December 5, 2011

MEMORANDUM

SUBJECT: Staff Analysis for Draft Reuse Permit LA-000147-03 (Municipal Recycled Water)
City of Murtaugh

Figure 1, Historic Ground Water Nitrate Concentrations

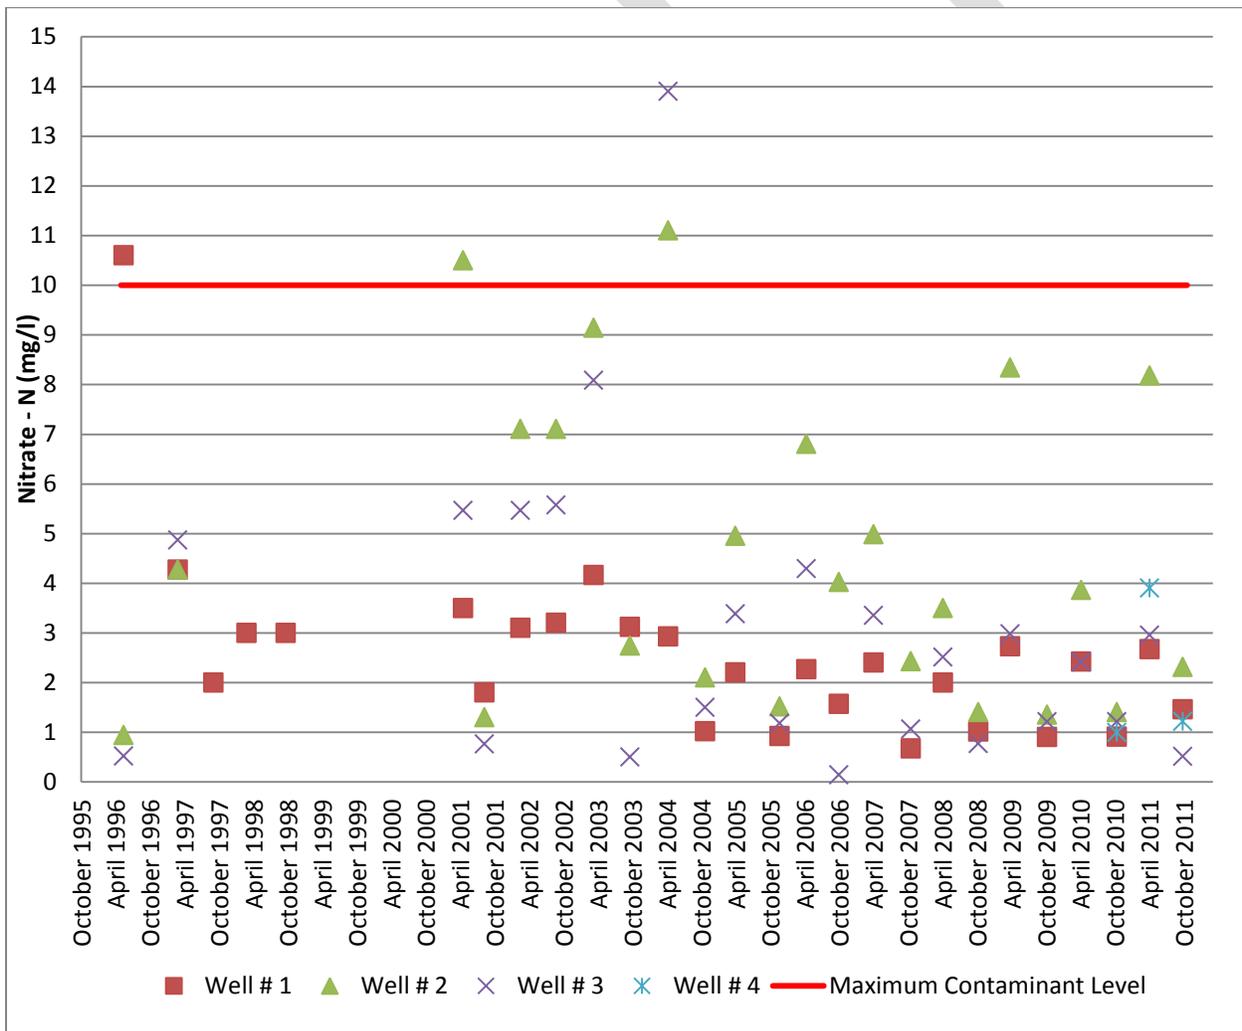
As shown in Figure 1, ground water concentrations of nitrate have occasionally exceeded the MCL. Though it appears that downgradient wells have higher nitrate concentrations than upgradient wells; this trend is not consistent among all downgradient wells or during all seasons. As the City’s permit renewal application suggests, the spike in nitrate concentration of downgradient wells may merely be an artifact of season influx of irrigation water, which affects both constituent concentrations in, and flow of, local ground water.

Recommendations: With the installation of a 3rd downgradient monitoring well (MW 4), a better indication of how seasonal changes affect ground water should be available, and could show that the application of effluent to the RIBs is not the primary cause of the high nitrate concentrations found in MW 2. Ground water modeling performed by the permittee's consultant suggests that the RIBs should not raise ground water nitrate concentrations beyond an acceptable amount; however, continued analysis of ground water monitoring will be required to determine if this modeling reflects reality. If further monitoring and analysis reveal that the locations of MW 3 and MW 4 provide a better indication of how well the RIBs are able to remove nitrogen, then no plan on how to increase RIB nitrogen removal capacity will be necessary.
